SUBJECT: Coastside Design Review  
Avenue Alhambra, El Granada  
APN 047-043-240; County File No. PLN 2016-00085

At its meeting of January 12, 2017, the San Mateo County Coastside Design Review Committee (CDRC) considered your application for a design review permit to allow construction of a new 3,067 sq. ft. two-story single-family residence (including a 587 sq. ft. attached two-car garage) on a 6,485 sq. ft. legal parcel (Certificate of Compliance recorded on November 12, 2015). The project involves minor grading and no tree removal.

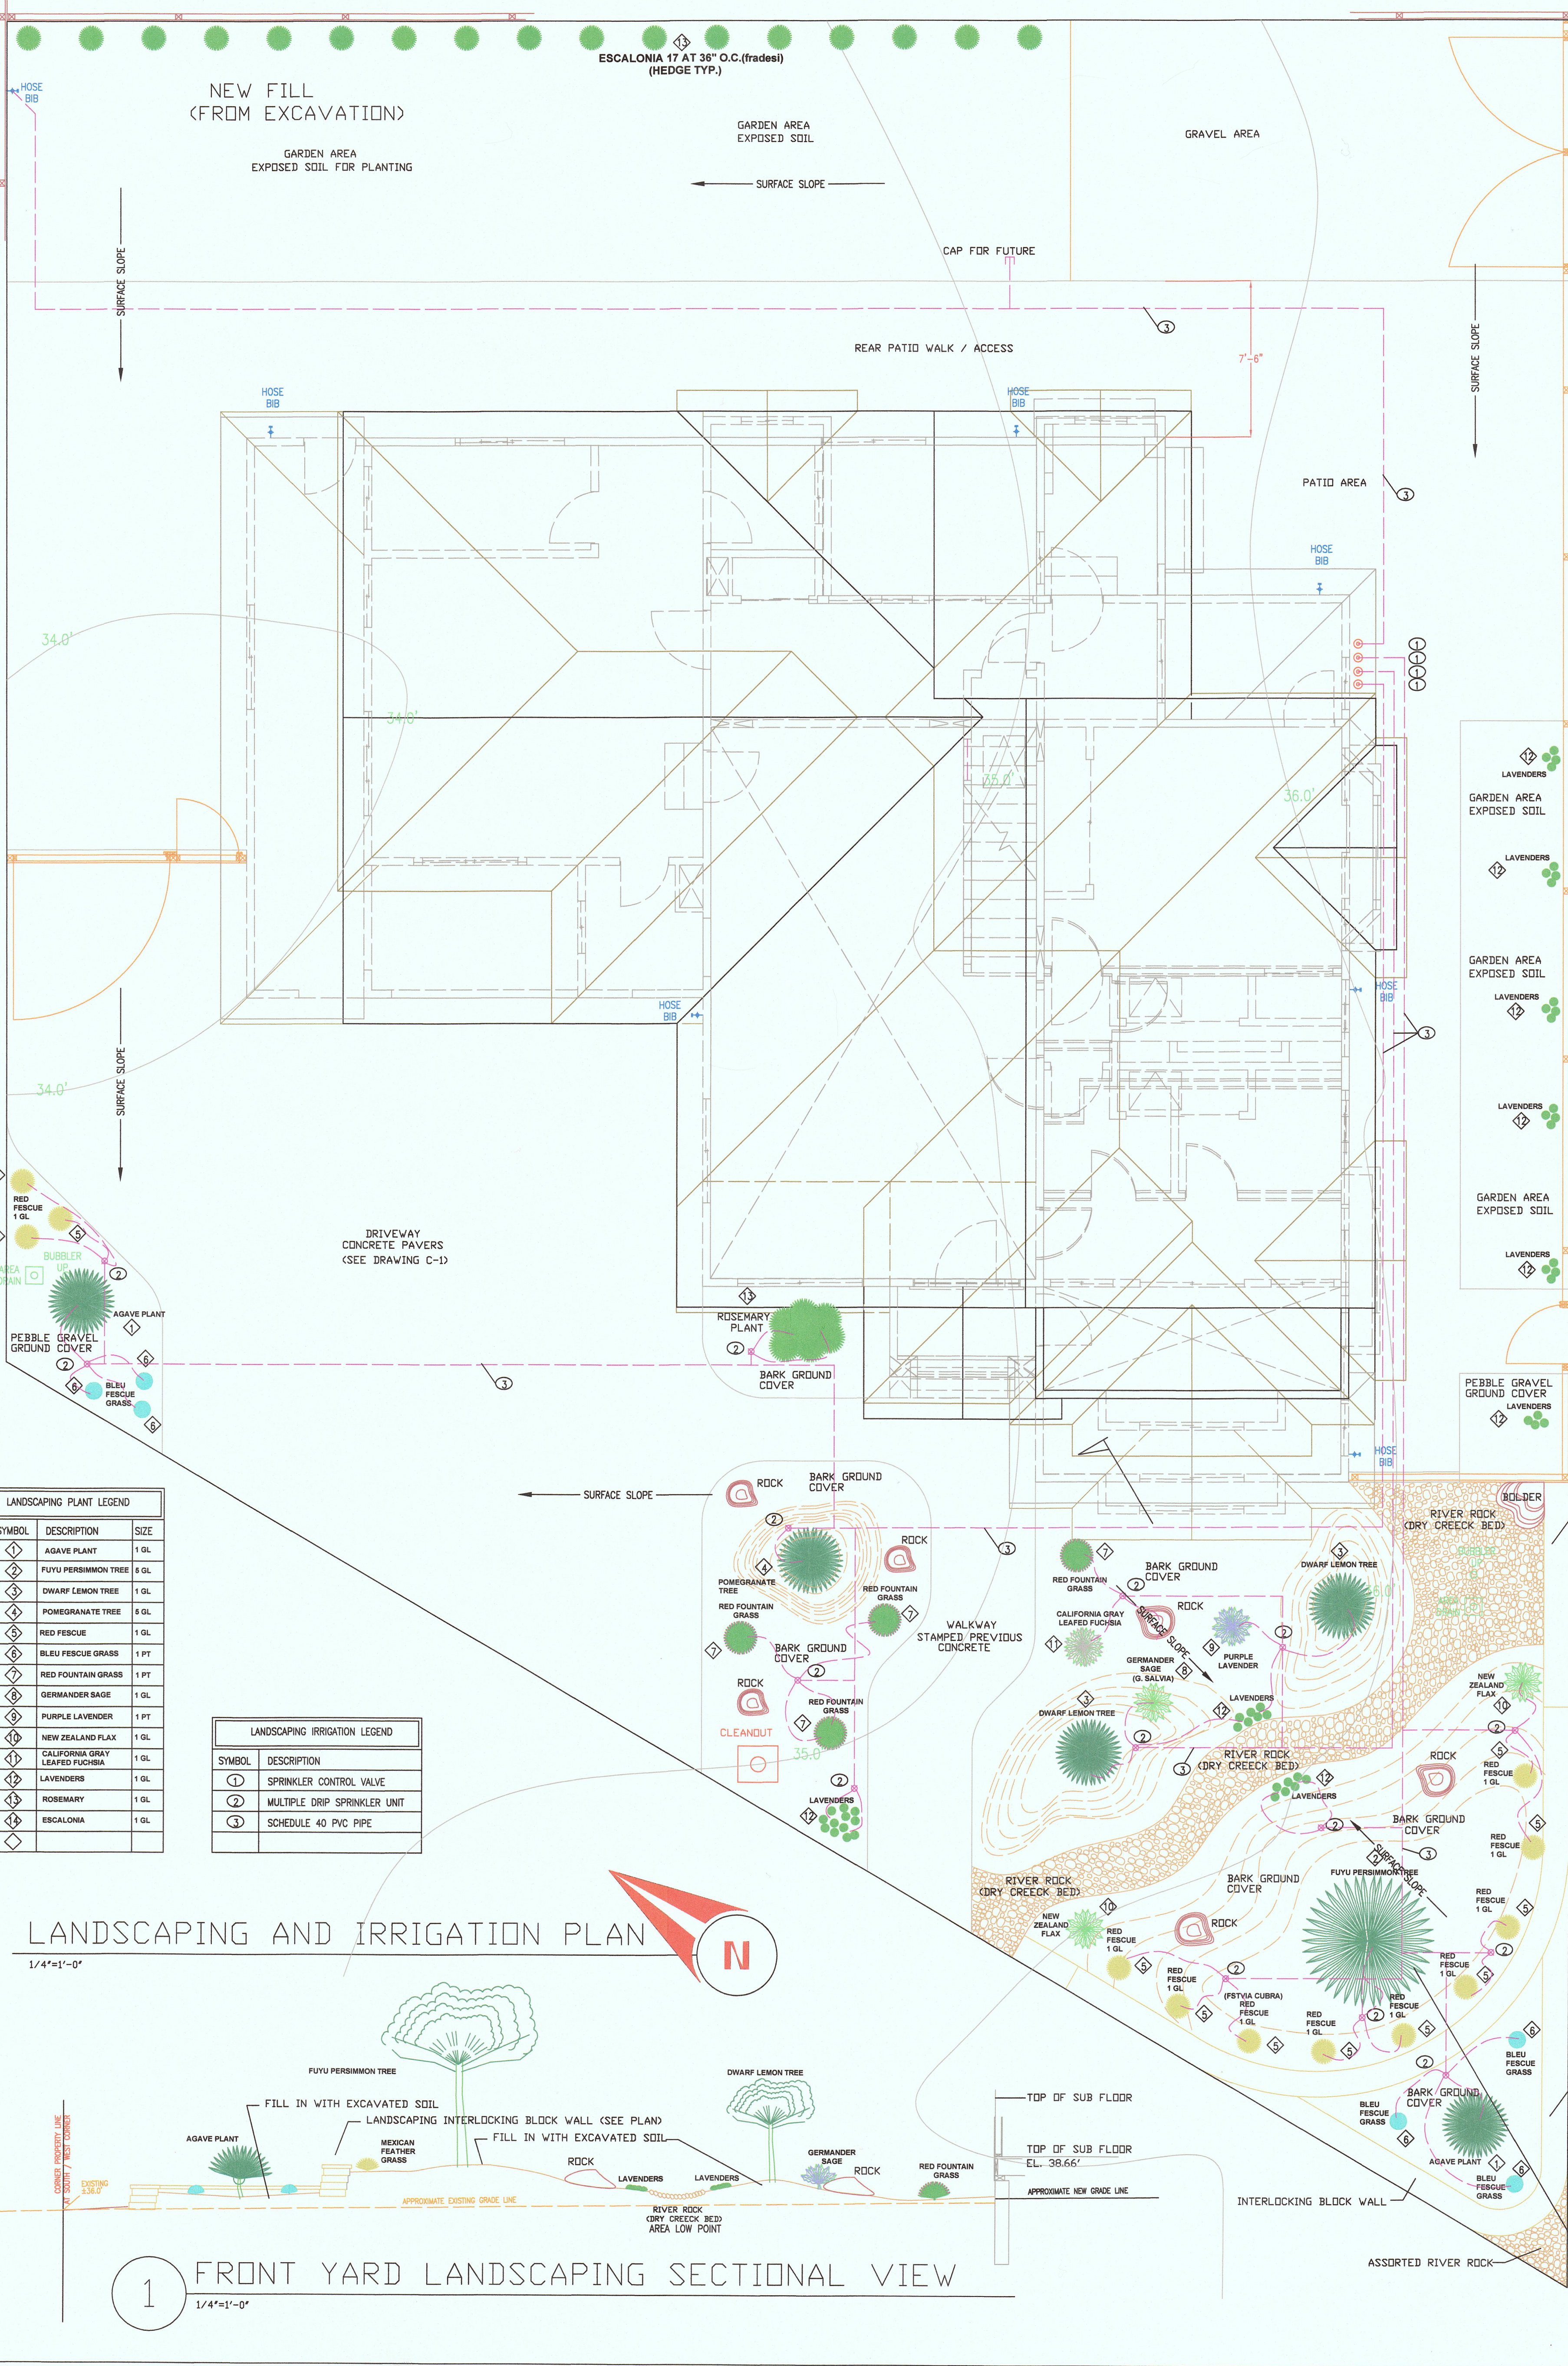
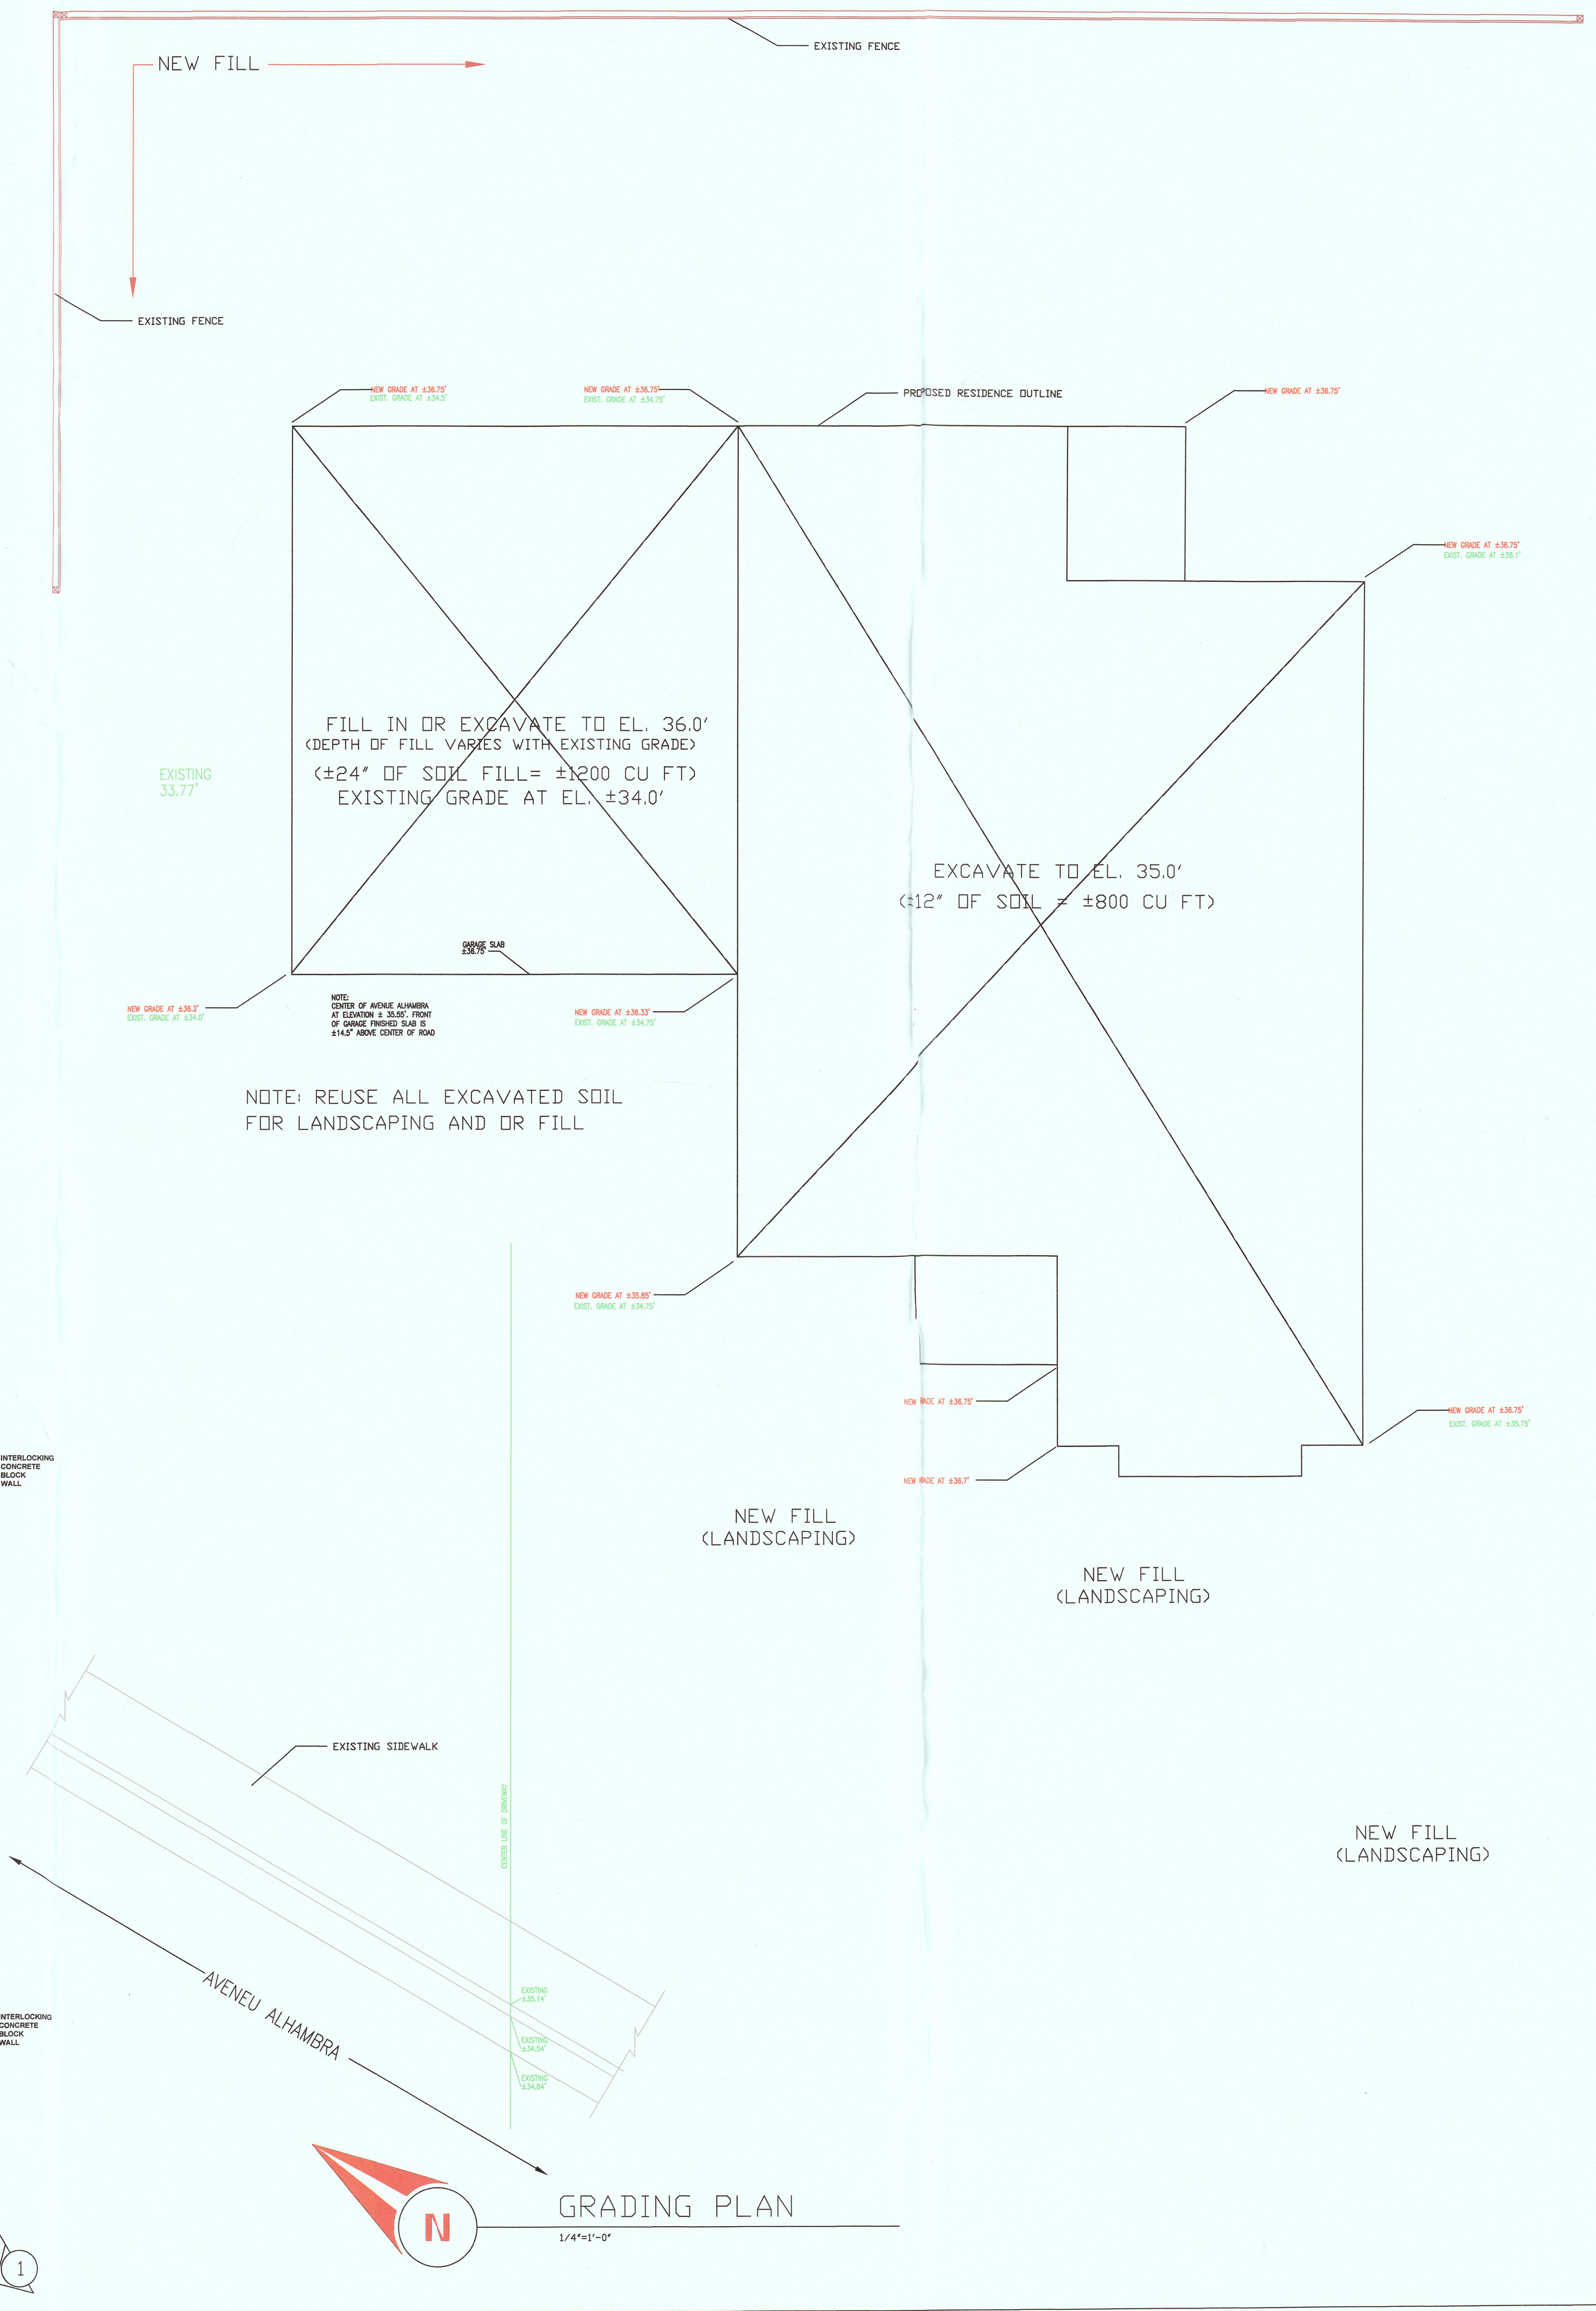
- d. Section 6565.20(F). LANDSCAPING, PAVED AREAS, FENCES, LIGHTING AND NOISE; 1. Landscaping; Standards (b) and (f). Further develop the landscape plan to provide for additional landscaping throughout the property to enhance the design of the house and complement the vegetation in the surrounding neighborhood (b); and use only drought-tolerant and either native or non-invasive plant species (f). Specifically, remove the Mexican Feather Grass from the landscape plan, and specify the size of the plantings indicated in the landscape plan.
